REVIEW OF VARIANCE REQUEST THE MEADOWS AT DEER CROSSING REVIEWED BY: STEVE HUDSON 09-25-23

VARIANCE FOR ROAD FRONTAGE

The Meadows at Deer Crossing

THE	MEADOWS AT DEER CROSSING VARIANCE REQUEST CR 3512 DIKE, TX
DATE:	09/19/2023
CCALE.	. LITE

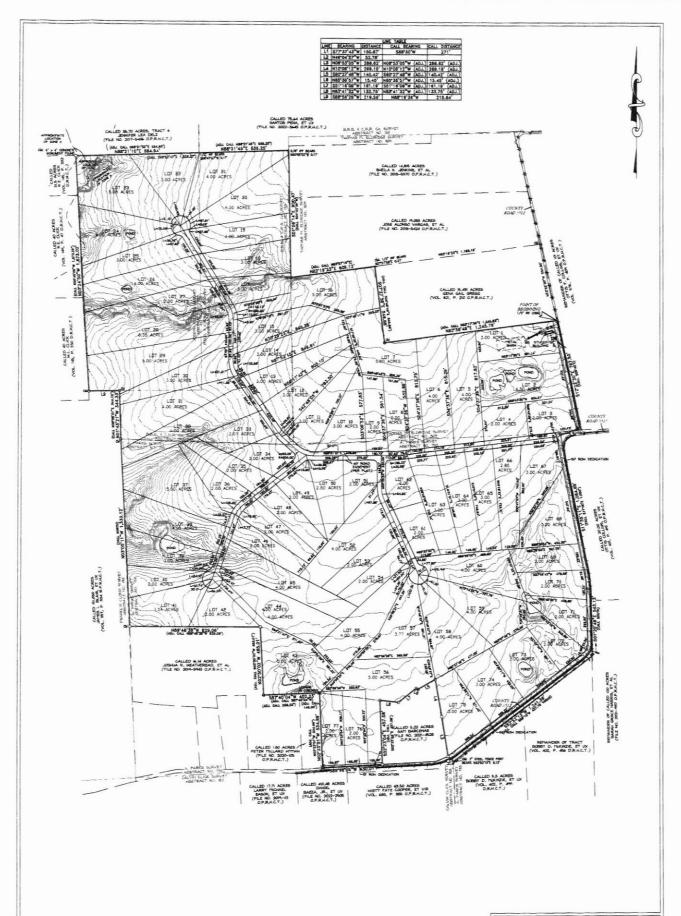
"We are requesting a variance on proposed lots in The Meadows at Deer Crossing. We are basing these on the previous approved road frontages of 100 feet and 50 feet along cul-de-sacs. The lots that do not meet the new regulations are as listed below:

Lot 7 - flag lot, 5.00 acres with 100' of frontage

Lot 8 - 2.00 acres with 137.40' of frontage

Lot 9 - 2.00 acres with 159.94' of frontage

Lot 14 - 3.00 acres with 175.38' of frontage

Lot 16 - flag lot, 5.00 acres with 110.17' of frontage

Lot 28 - 6.35 acres with 214.71' of frontage

Lot 29 - flag lot, 5.00 acres with 100' of frontage

Lot 31 - 4.00 acres with 100' of frontage

Lot 37 - 5.00 acres with 100.04' of frontage

Lot 47 - 2.00 acres with 173.82' of frontage

Lot 48 - 2.00 acres with 176.67' of frontage

Lot 53 - 2.00 acres with 150.00' of frontage

Lot 54 - 2.00 acres with 150.00' of frontage

Lot 56 - flag lot, 5.00 acres with 100.00' of frontage

Lot 69 - 2.00 acres with 190.22' of frontage

Lot 76 - 2.00 acres with 165.35' of frontage

Lot 77 - 2.00 acres with 164.67' of frontage "

The Court spent many hours recently during two work sessions researching, reviewing, and discussing the recently adopted frontage requirements. The work sessions and court agendas for discussion and adoption, were properly posted in advance of those meetings. As you are aware, no opposition was voiced.

Staff recommends denial of this request.
